**BEFORE THE PUBLIC UTILITY COMMISSION
OF OREGON
LC 70**

**OPENING COMMENTS
OF THE
OREGON CITIZENS' UTILITY BOARD**

January 10, 2020

Figure 1 - 1: Seventh Plan Resource Portfolio¹

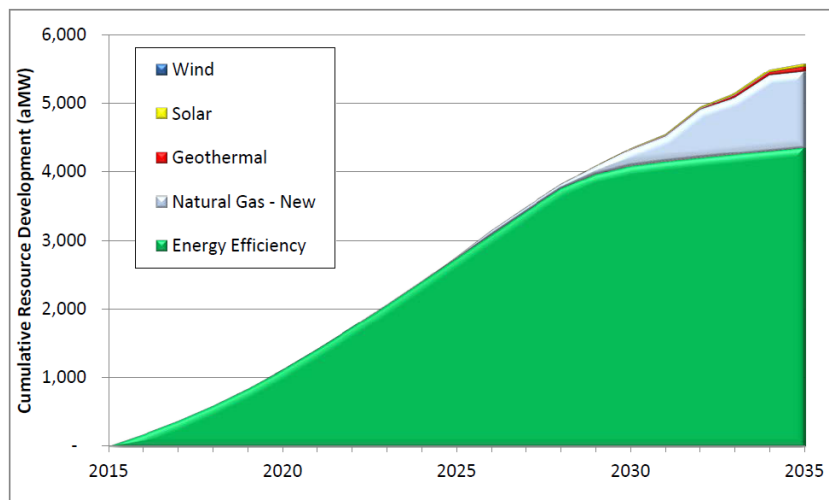
The Power Plan makes acquiring energy efficiency its primary near-term resource action. The Power Plan also identifies demand response as its second priority and considers this resource to be best suited to meet capacity needs under low water and extreme weather conditions.
